TOWN OF PLAINFIELD DESIGN REVIEW COMMITTEE

CASE NO.: [DP-26-082](#)

Project Page: Larry Good Homes Office Suites

REQUESTED ACTIONS: Architectural & Site Design Review for a proposed 8,100 square foot office building

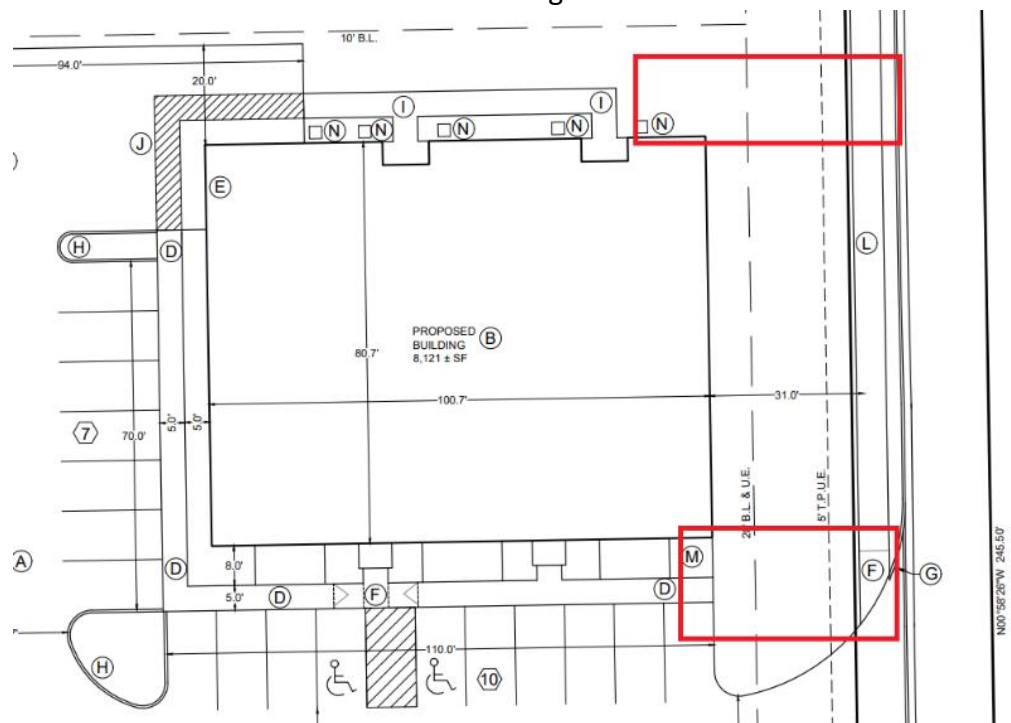
The submitted plans do not appear to provide a connection between the sidewalks surrounding the proposed building and the sidewalk proposed to run along Clarks Creek Road. The pedestrian network must provide a continuous connection between the building and public sidewalk. The areas highlighted in red below depict where those connections seem to be missing.
